**Resolution Copper Project and Land Exchange
Environmental Impact Statement**

Process Memorandum to File

Assessment of Factual Basis for Comments on Dewatering Amounts, Water Usage, and Power Usage

**Prepared by:
Chris Garrett
SWCA Environmental Consultants**

Figure 1. Reported dewatering rate between 2010 and 2018

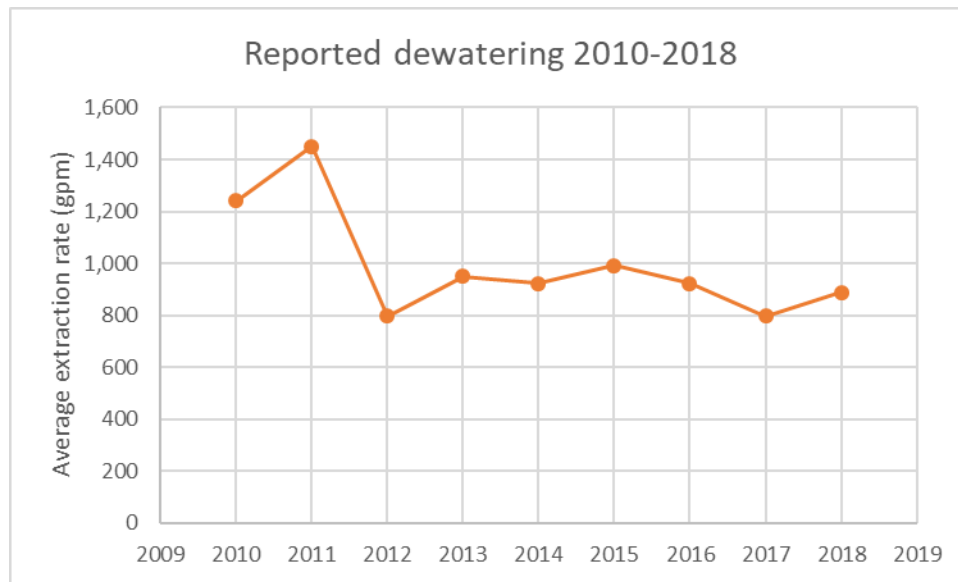
Because extrapolating from single data points is not always appropriate, activities that reflect the combined response of the entire aquifer are especially useful. In this case, Resolution Copper has been pumping from a suite of wells on the north and south side of Highway 60 near Shafts 3 and 10 since 2009, which has resulted in a reduction in groundwater levels in the deep groundwater system (see DEIS, p. 309). The pumping is being conducted under a dewatering permit issued by the Arizona Department of Water Resources (permit 59-524492.0003). This pumping represents the physical amount of water necessary to be removed in order to maintain water levels within the Resolution Graben (where the ore body is located) to a level of about sea level. The following pumping amounts have been reported to ADWR⁴.

As shown in table 1 and figure 1, dewatering rates have been consistent after the first two years of pumping, averaging between 800 and 1,000 gpm. This more accurately reflects anticipated dewatering amounts for the entire mine area than the flow from a single fracture network encountered by Shaft 10.
